Reasons for Decision

Conditional Approval of 2019 Final Closure Plan for Cobble Hill Holdings Landfill

**Re: Leachate Generation Review – Task 4
Review of the Cobble Hill Landfill Updated Final Closure Plan 2019
460 Stebbings Road Near Shawnigan Lake, British Columbia**

RE: Review of Groundwater Information in the Cobble Hill Landfill Closure Plan

Plot 3 shows the difference between the geochemical character of water from MW3S and leachate

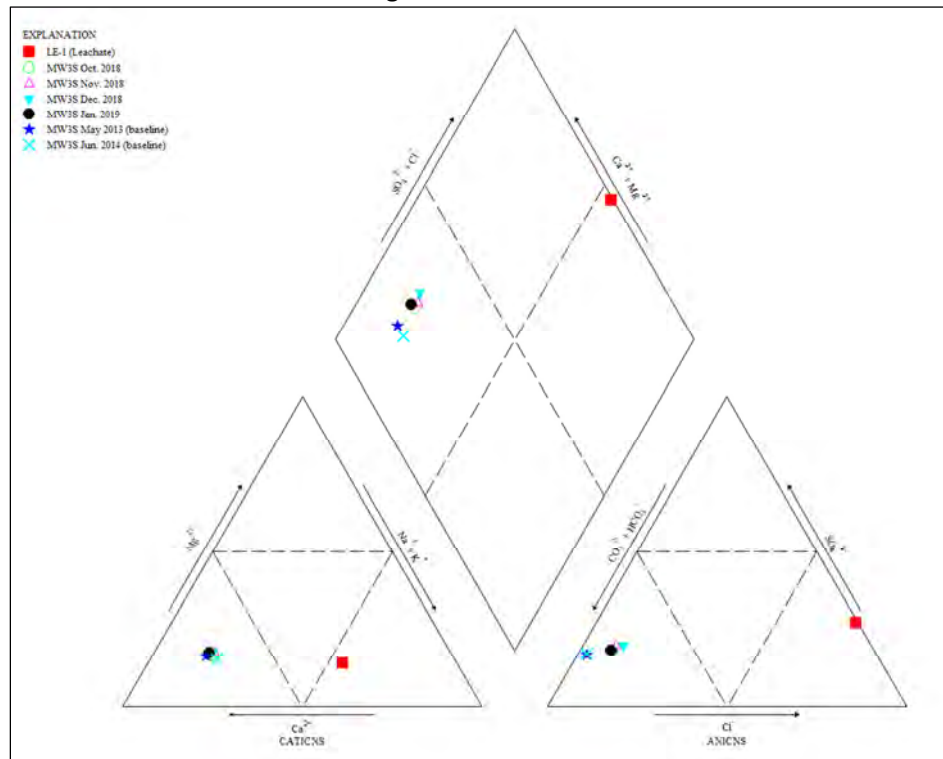
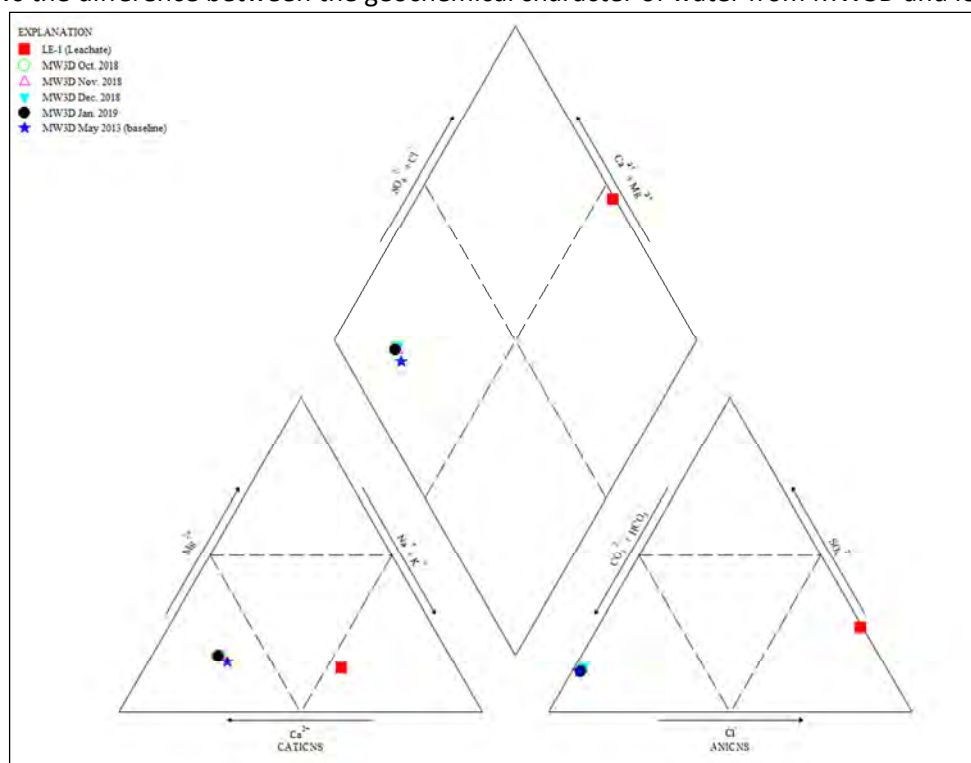
The trilinear plots shown below indicate that there is no obvious connection between the geochemical character of leachate and the groundwater samples collected from MW3S and MW3D. However, while the data from MW3D is plotted within the same cluster, the data from MW3S (Plot 3) shows a slight change or potential evolution between the recent and baseline results. This interpretation is consistent with the minor increases in some indicator parameters noted above.

Plot 6 shows the difference between the geochemical character of leachate and water from SB1, SB2 and SB3 in April 2018.

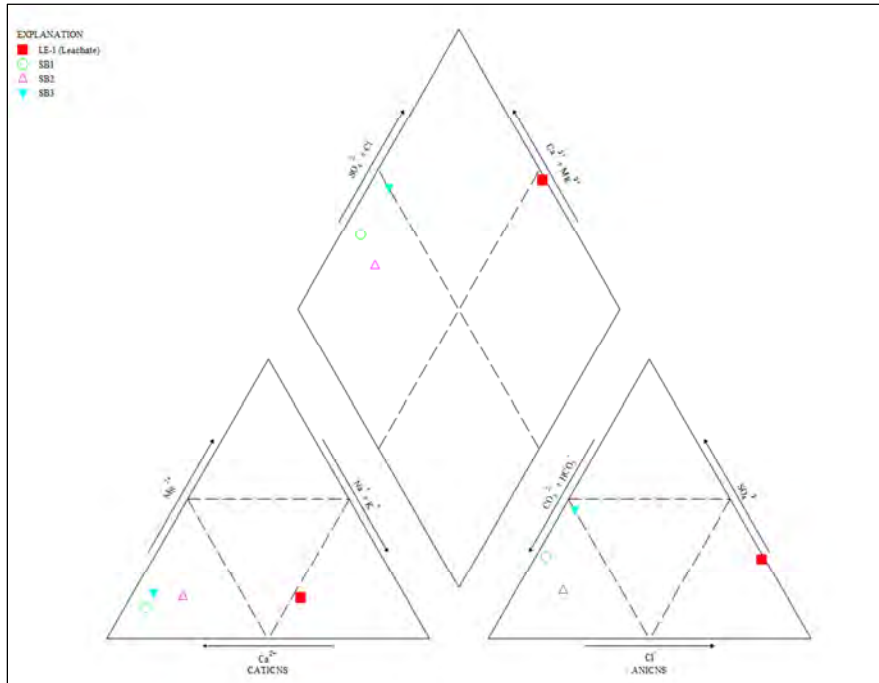
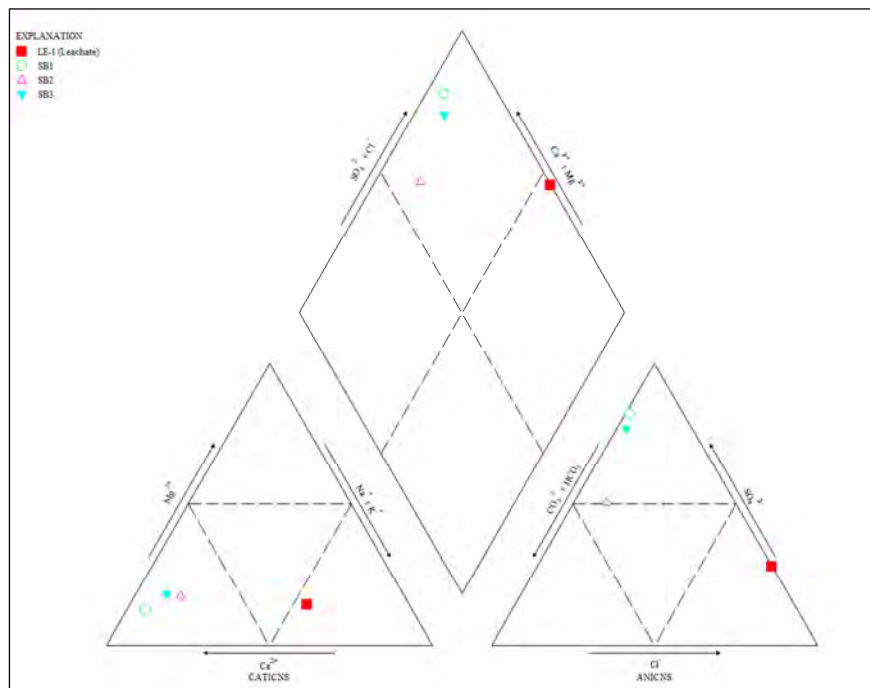
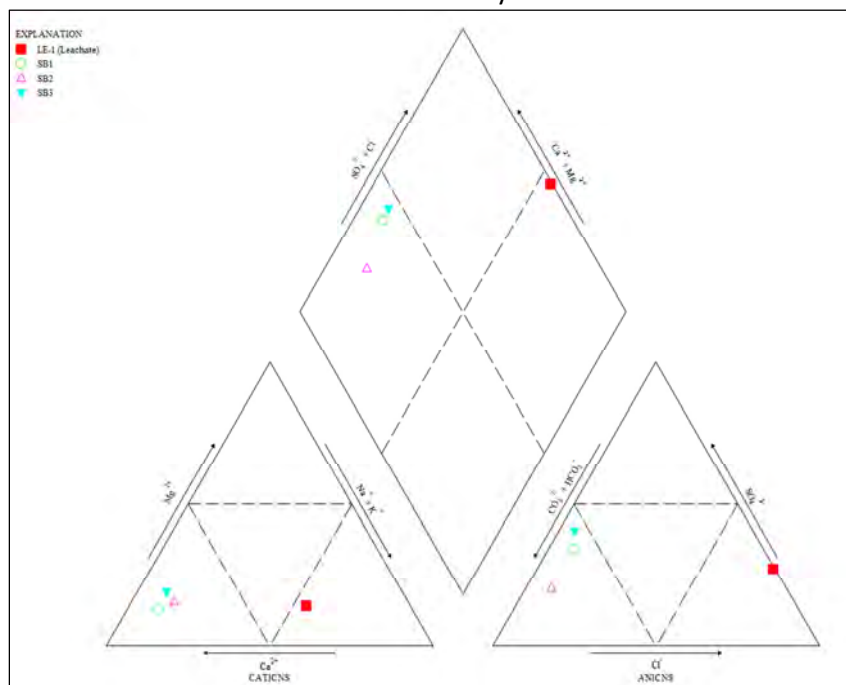
The following trilinear plots depict the geochemical character of water collected from the three interflow wells. The plots indicate that the geochemical character differs between the seasons. Plots 6, 7 and 8 indicate notable seasonal fluctuations in the water chemistry in the interflow wells. The fluctuations are influenced by precipitation such that the chemistry is elevated at the beginning of the rainy season (October and November) as a result of the fall flush, which washes out accumulated dust and oxidized materials within the quarry. This interpretation is supported by the sulphate enriched

water shown in Plot 7, which corresponds to the beginning of the rainy season. Plot 8 depicts the geochemical character from the later part of the rainy season (January), in which the water character is similar to the character from the previous spring (Plot 6).

Graph 1. Time-series depicting chloride concentrations in monitoring wells MW2, MW3S and MW3D.

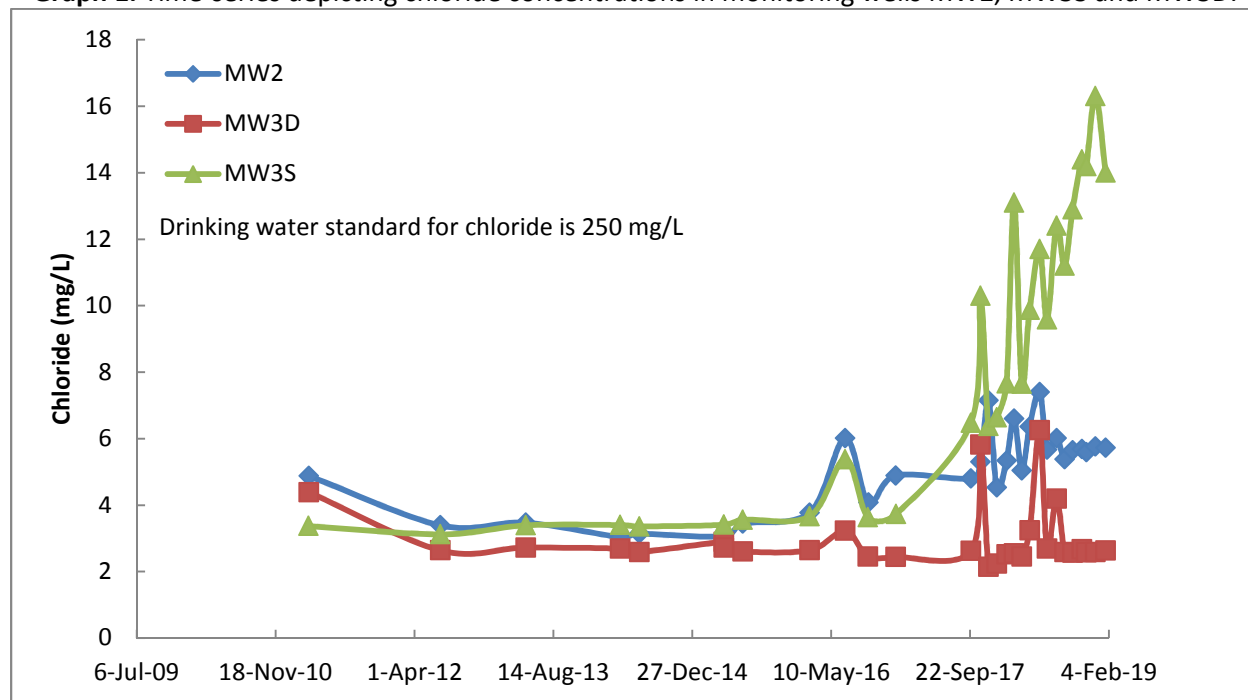
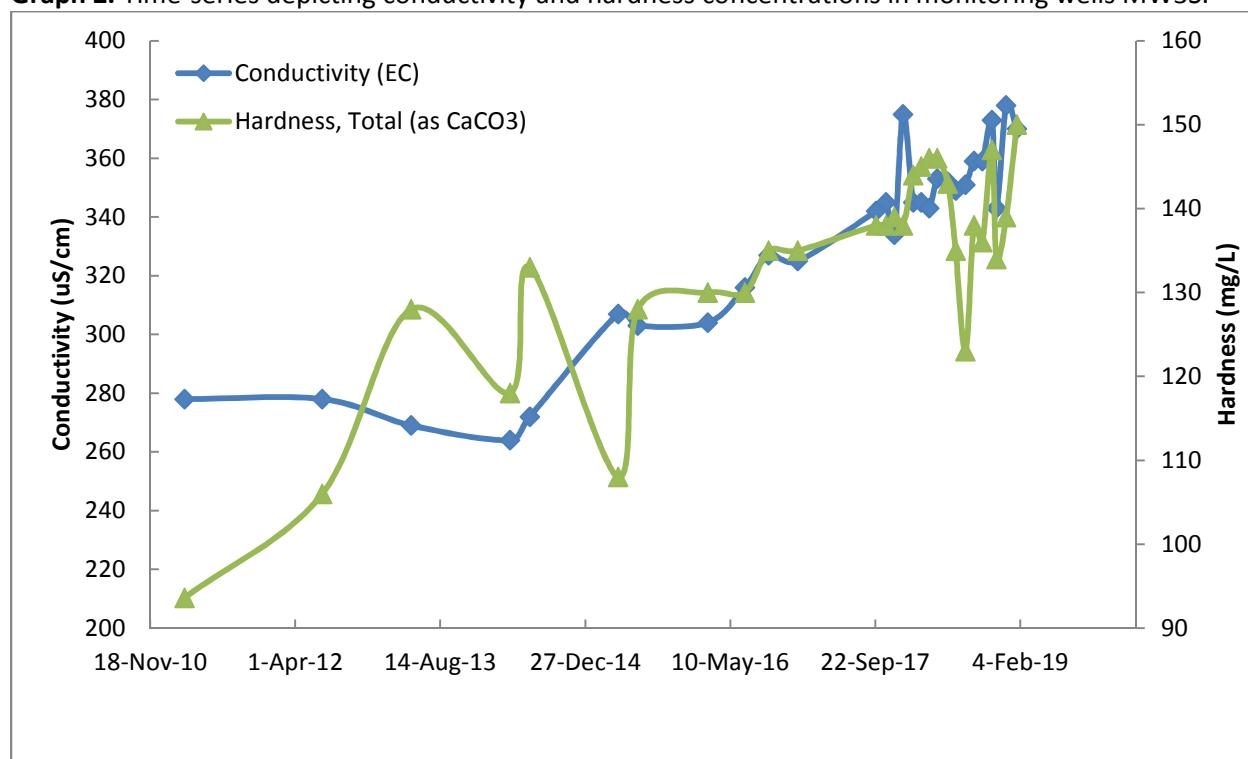
The conceptual hydrogeological model presented in the Closure Plan is incomplete and inconsistent with the available information. The model is therefore unlikely to effectively guide the monitoring efforts at the landfill. **I recommend that the conceptual model is revised as a condition of the landfill closure.**

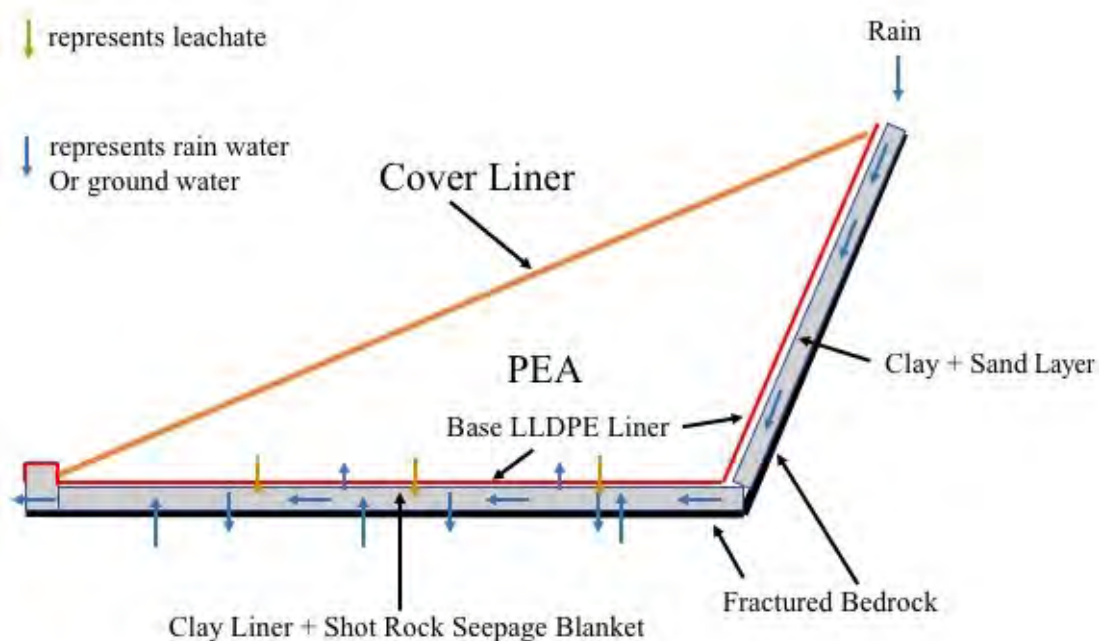
Figure 1 illustrates how rain water and ground water can penetrate the base of the PEA.

We did point the problem with the Leak Detection/Collection System to SHA in the January 4, 2019 meeting. The problem pointed out by Hemmera is illustrated in Figure 1 of this Critique. Why is SHA ignoring yet again information provided by the SRG?

Figure 2. Water levels in the monitoring wells shown taken from the Quarter 3, 2016 Report by the Named Parties.

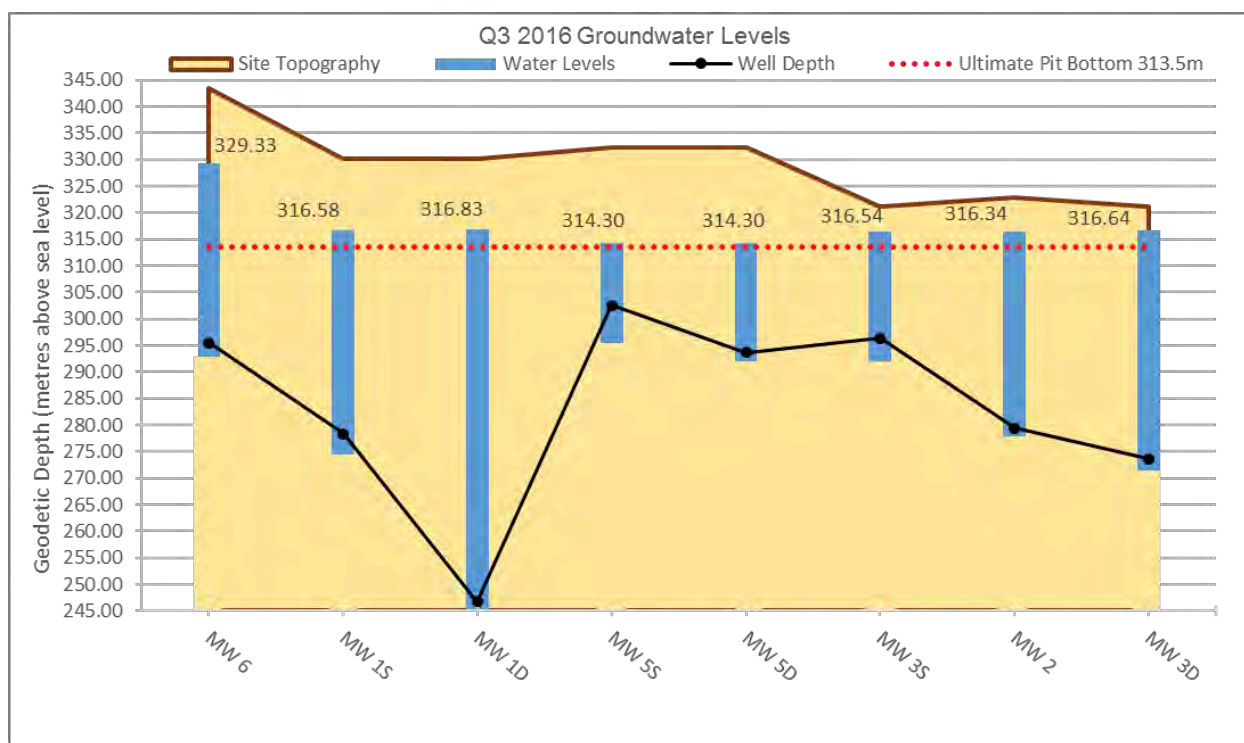
Further, SHA's Figure 6.2 represents a very selective use of data. It uses data from the rainy months when rain water influences the levels of the wells. One notes at the bottom of the graph shown in the Updated Final Closure Plans's Figure 6.2 that in the summer and early fall period of 2018, the wells are at essentially the same metres above sea levels. This is also seen in the Groundwater levels figure in the Quarter 3 Report of 2016 (Page 7 of the Report (p. 13 of pdf) and shown as Figure 2 in this Critique. Here there is essentially no difference between MW#1S and MW#3D and wells in between. Using winter well level data to argue the direction water will travel we consider to be deceptive.

Figure 2: Note the base liner fold and an apparent gouge possibly formed by excavator track – see Figures 5 & 6.

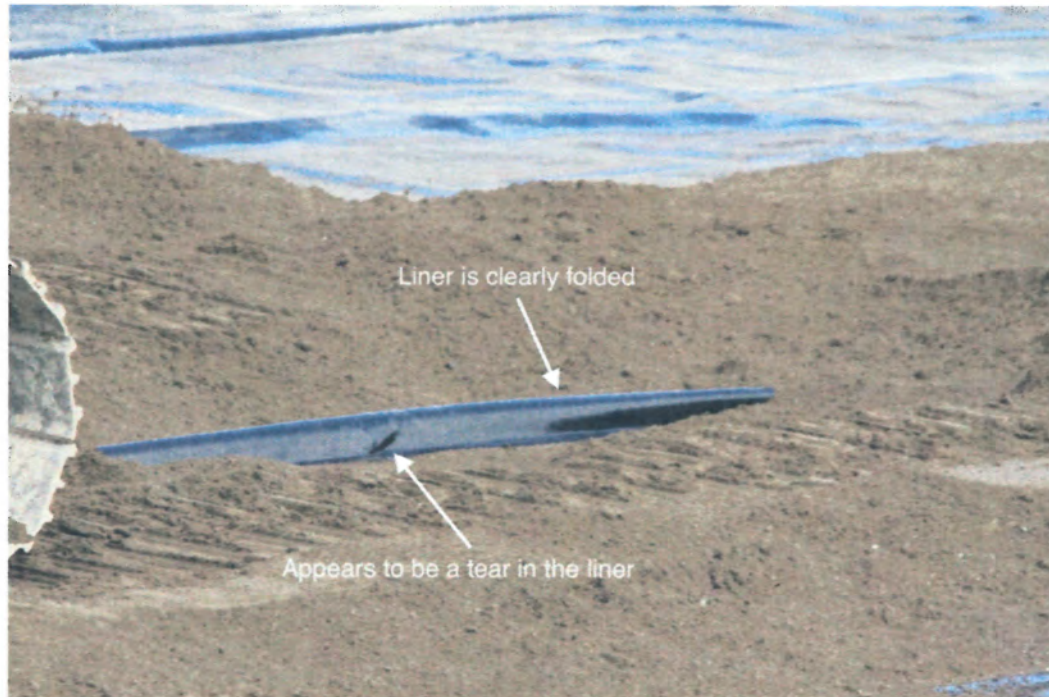
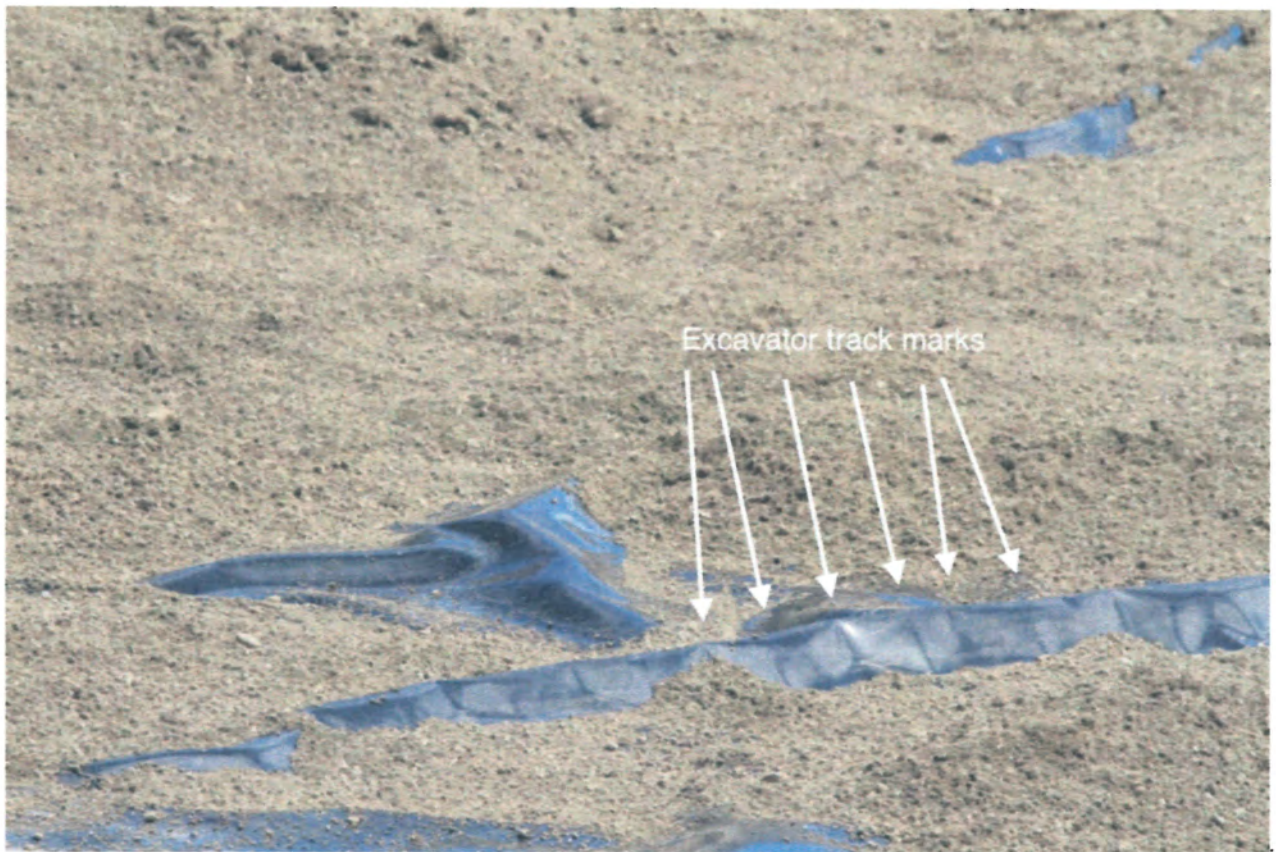
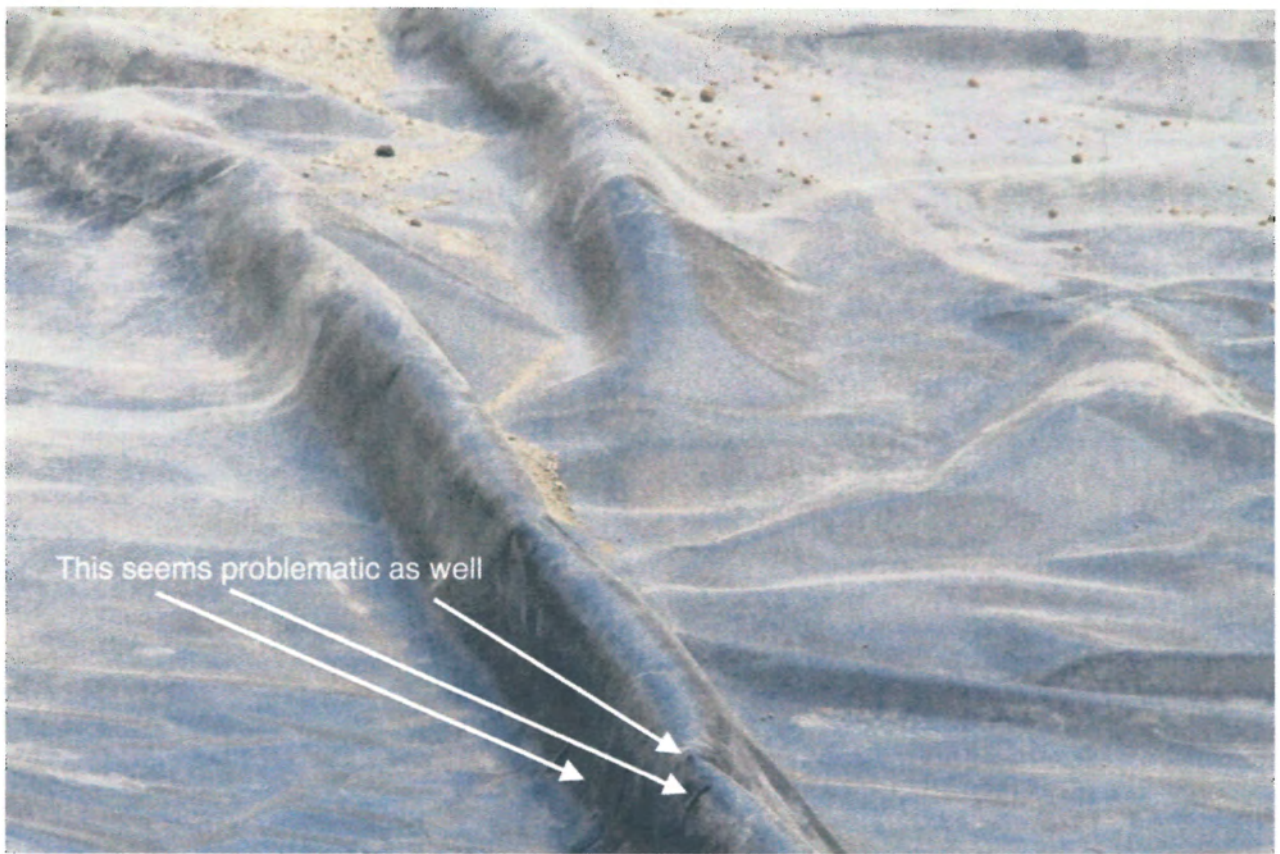
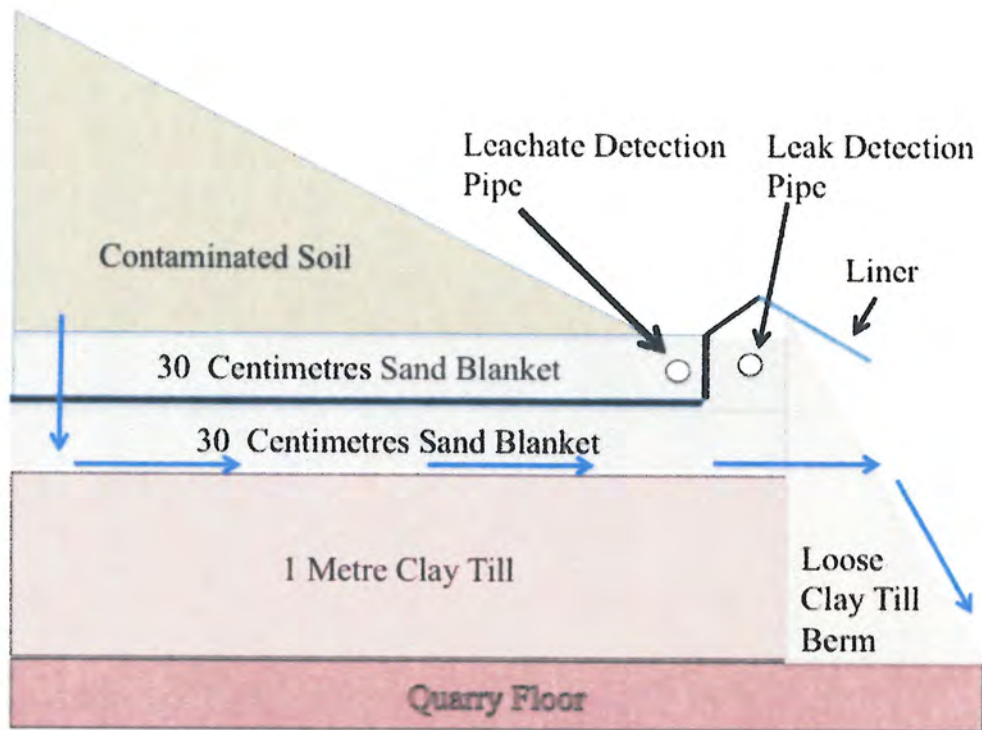
Figure 6: The so-called “leak detection system” designed by SIRM. The leaks would have to go **uphill** through sand and coarse crushed rock to enter the leak detection pipe. The simplest route for leaks is to flow through the sand blanket below the liner and through the loose clay till berm and from there the leak makes its way ultimately to the Ephemeral Stream. This is the source of the wet patches seen in Figure 4.
